No. 93-27

A. ENGINE CONTROL MODULE (ECM) RECALL

MCM 502 EFI Stern Drive Engines

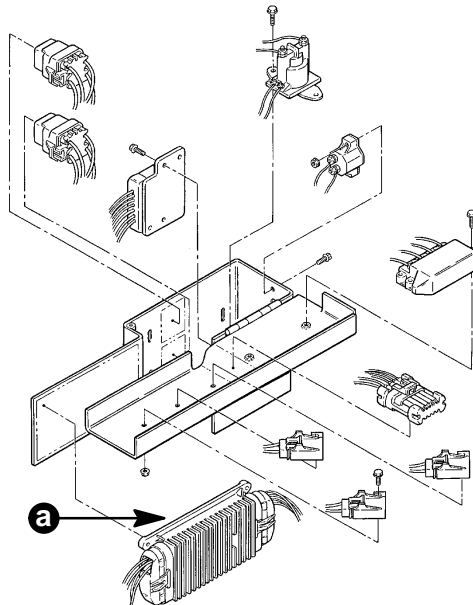
Two calibration changes have been made to production ECMs. 1. Better response to detonation. 2. Prevention of giving a false Diagnostic Trouble Code (DTC) 43. (DTC 43 indicates a problem in the Knock Sensor Circuit).

▲ Order a new Engine Control Module. If ECM has 935F or 9352 on it, it has already been changed.

a. - ▲ Number 935F or 9352 DO NOT Change.
Numbers 9550, 9300 or 931E Change.

(1) 806709T 5 Engine Control Module (ECM).
